49 REEVES WAY WOKINGHAM RG41 2PS

Application Number: 260063

PROPOSED ERECTION OF A SINGLE STOREY REAR EXTENSION FOLLOWING DEMOLITION OF THE EXISTING CONSERVATORY, PLUS CHANGES TO FENESTRATION

Formal Objection to Planning Application at 49 Reeves Way

Current planning application showing relative size and mass of proposed extension causing visual impact, eye-sore and loss of aerial light to 47 Reeves Way

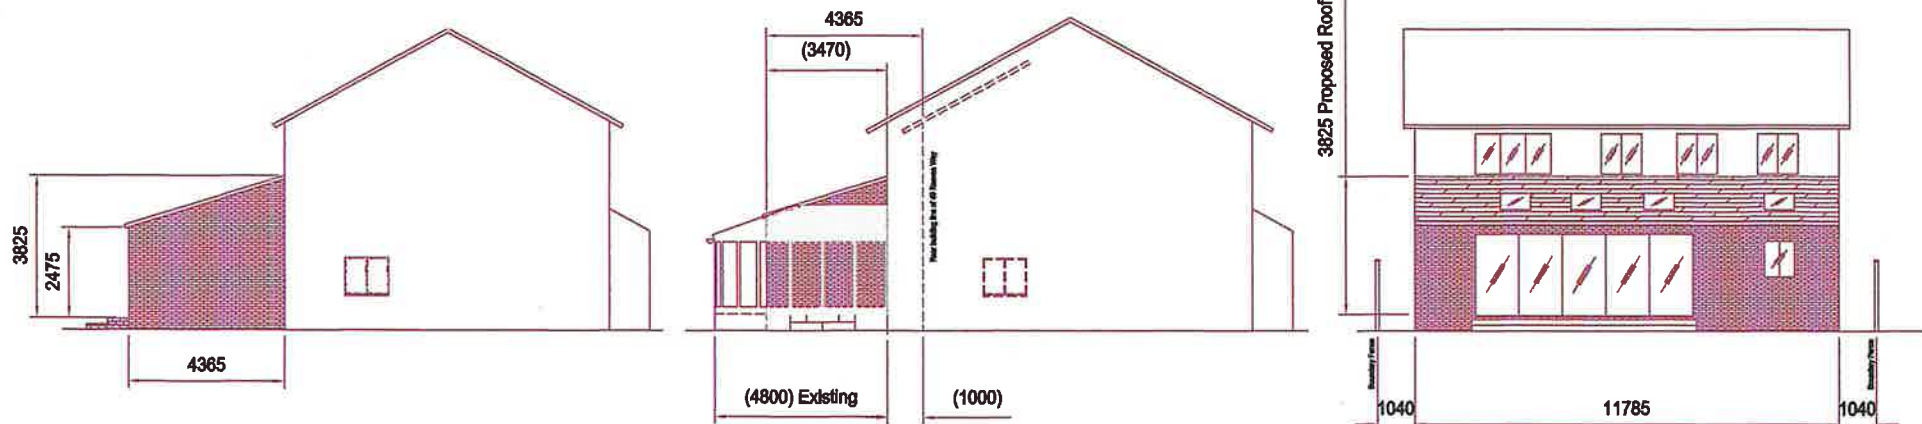
The extension as submitted is of substantial size, and due to its placement directly along our shared boundary, the massing would be excessively dominant when viewed from our conservatory, which serves as a dining room and office and is used throughout the day. The design incorporates a single-pitch roof sloping upwards towards the existing first-floor structure, resulting in significant height and two large, uninterrupted brick walls framing the sides of the extension. As a direct neighbour, the outlook from our main rear living space would be of a tall, featureless brick elevation in very close proximity, creating an oppressive and overbearing visual environment.

The proposed extension is positioned approximately **1000mm from the boundary** between our properties. Based on this measurement, I believe that the **2-Metre Rule** applies, which states that where an extension is built within 2 metres of a boundary, the eaves height should not exceed **3 metres**. As currently designed, the eaves and overall massing appear to exceed what could reasonably be considered acceptable in such close proximity to a neighbouring property.

From our own calculations, the proposed extension would obstruct approximately **82% of the side-light** entering our conservatory and would reduce our outward view by around **3470mm**. Such a dramatic loss of natural light would significantly impact the usability and enjoyment of this important living space. To mitigate this, I propose a **2000mm reduction in width**, set further away from the boundary, which is also reflected in the measured drawings included with the hard-copy submission.

The application also includes a **new side-facing window** at 49 Reeves Way, positioned directly opposite our conservatory. This window is of standard full-height dimensions and, in its proposed location, would result in a direct and unacceptable loss of privacy to our property.

Suggestions of changes to planning application on the grounds of: planning rules, lessening of size, visual impact and loss of light to 47 Reeves Way

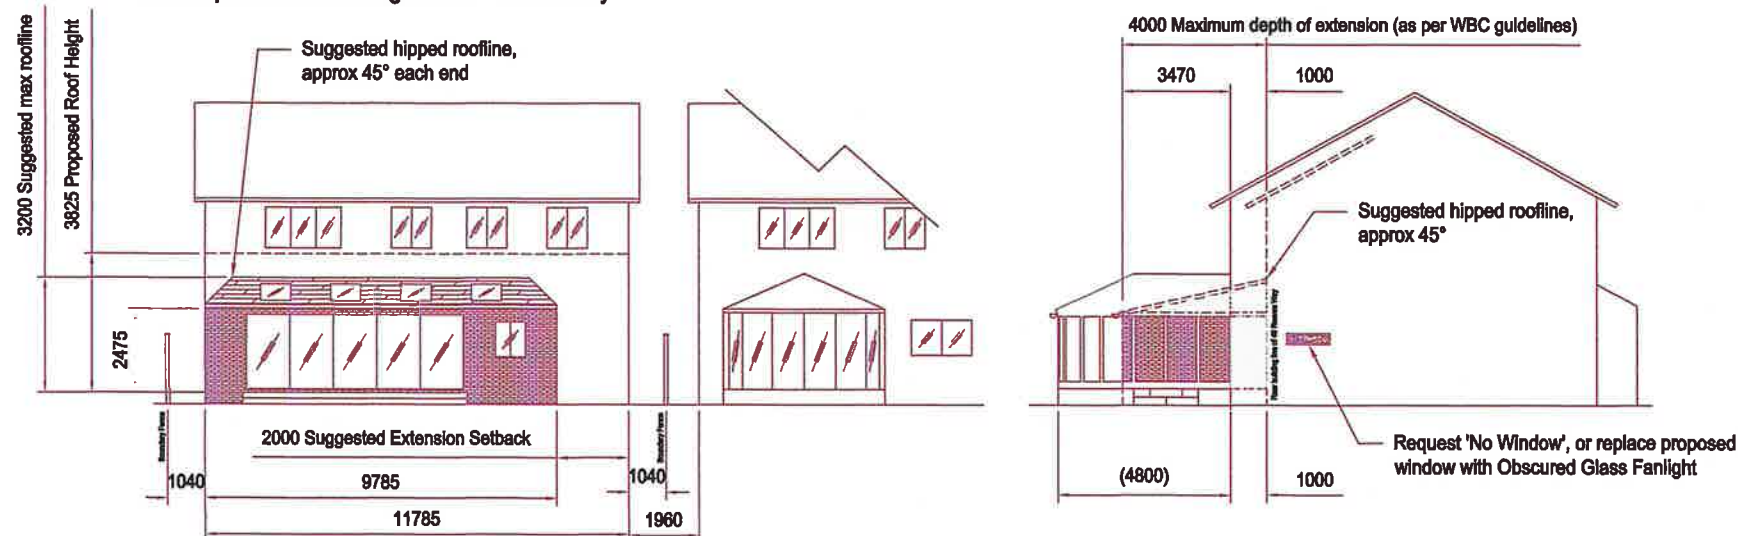
I respectfully contend that this design approach is not sympathetic to the existing character of the locality or to the pattern of neighbouring extensions. A more appropriate alternative would be the adoption of a **hipped roof**, incorporating three roof planes — sloping from both sides as well as the rear — which would help reduce the perceived bulk and height of the extension. A hipped roof would not only be visually softer but would also be more consistent with neighbouring extensions,

To reduce the overbearing impact and ensure compliance with established planning principles, I believe that a reduction in both the **depth** (from 4365mm to 4000mm) and the **width** (from 11785mm to 9785mm) of the extension is both justified and necessary. These changes would substantially lessen the overshadowing effect and the extent to which the extension dominates the shared boundary.

- **removed entirely, or**
- **replaced with a high-level fanlight window fitted with obscured glazing**, which would prevent overlooking while still allowing ventilation if required.
